RE: U. S. Titanium Superfund Site
Railroad Right-of-Way Evaluation
Response to EPA Comments & Revised Report

**REPORT
ON
RAILROAD RIGHT-OF-WAY EVALUATION
FOR
pH, IRON and ACIDITY**

**U. S. Titanium Site
Piney River, Virginia**

**CYTEC RESPONSES TO USEPA COMMENTS (DATED JANUARY 22, 2002)
ON THE DECEMBER 5, 2001 REPORT ON RAILROAD RIGHT-OF-WAY
EVALUATION FOR THE U.S. TITANIUM SUPERFUND SITE**

TABLE 3 - PROPOSED SAMPLING LOCATIONS FOR DITCH SECTIONS

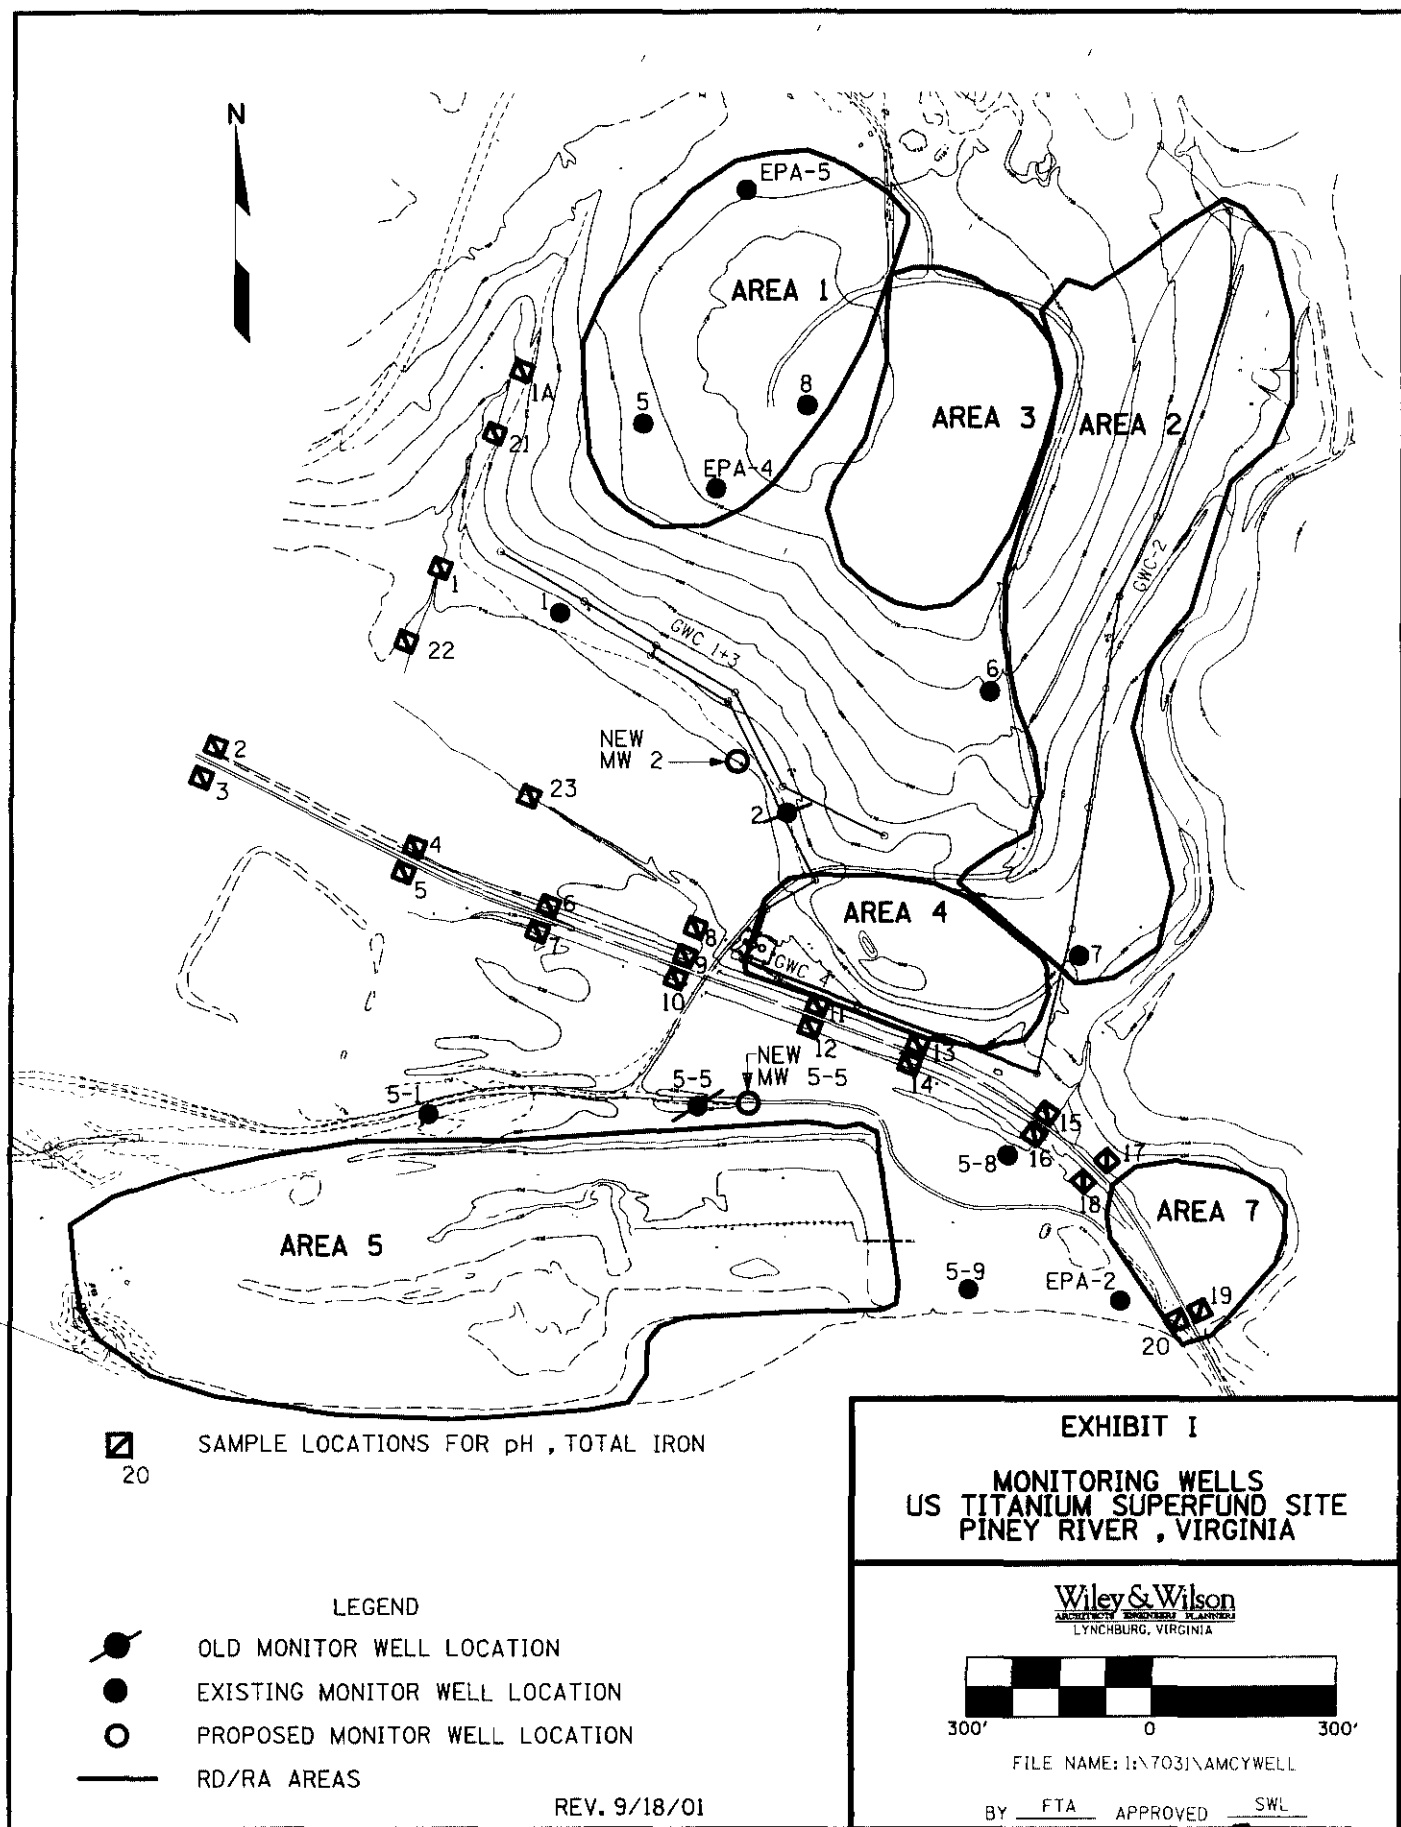
The discussion on page 8, second paragraph, regarding the determination of final lime application rates is somewhat confusing. The example is given of locations 3 & 5 where total acidity readings are similar and therefore, samples will be collected at 50 foot intervals and composited to determine the final rate. If results aren't similar does the sampling methodology change? In other words, does the sampling interval change and are discrete as opposed to composite samples collected?

No, if results aren't similar, the sampling methodology of collecting a sample every 50 feet for compositing will not change; however, the length of the sampling segment will change. This section of the report has been expanded to include more examples. In addition, a Table 3 has been added to show the proposed sampling locations for the various ditch sections. Please see Section 4 – FUTURE ACTIONS, Method to Determine Lime Application Rate and Table 3 in the revised report.
